MSO9404A-03

S E R V I C E N O T E

MSO9404A - 4GHz Mixed Signal Oscilloscope

Repair for Windows "Power surge on hub" message

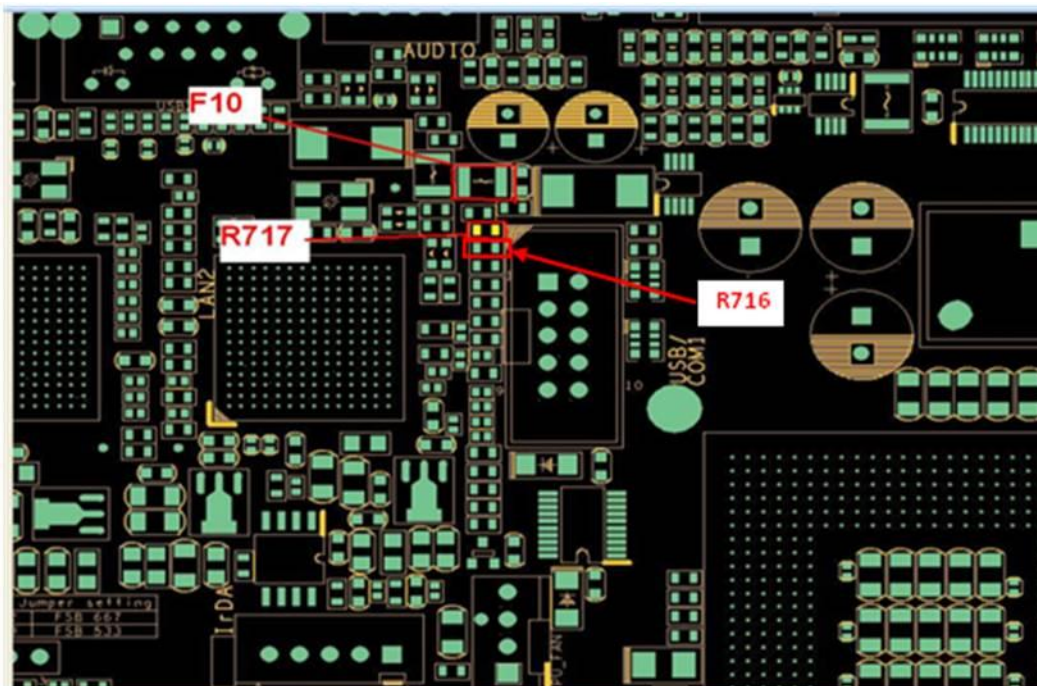
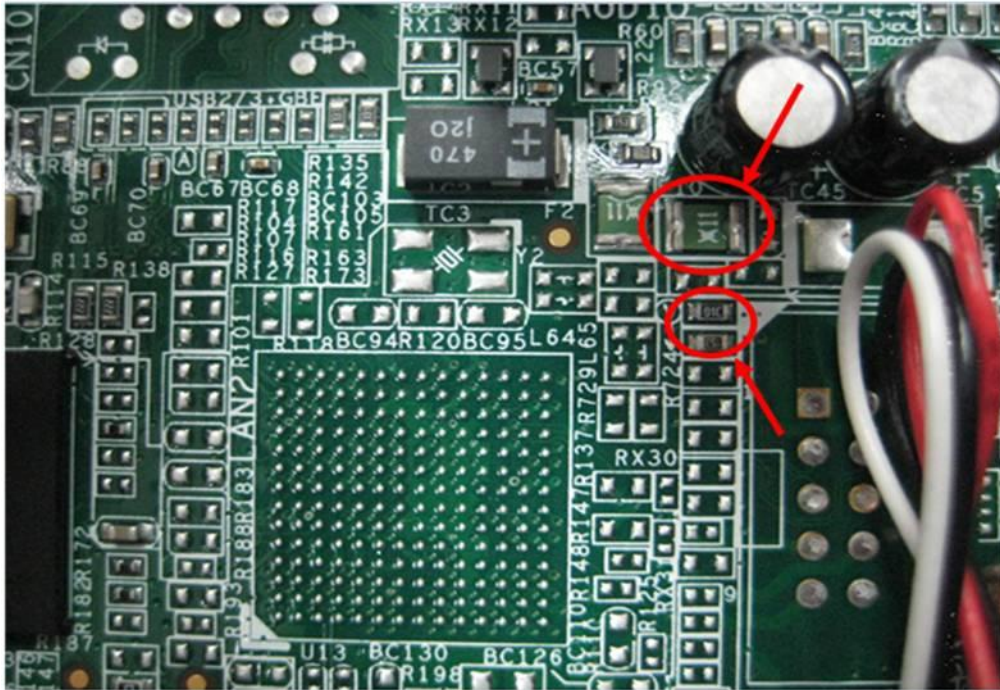
1. Refer to the service manual to remove the motherboard from the scope.
2. Install the three components from the upgrade kit on the motherboard. Refer to the below drawing and the drawing on the next page for component locations. The 0960-2789 motherboard is RoHS compliant and the below three components are also RoHS compliant. You should use a RoHS soldering station and RoHS solder techniques when possible.

F10 – 0837-3854 Thermistor

R717 – 0699-7654 10K Resistor

R716 – 0699-5789 15K resistor
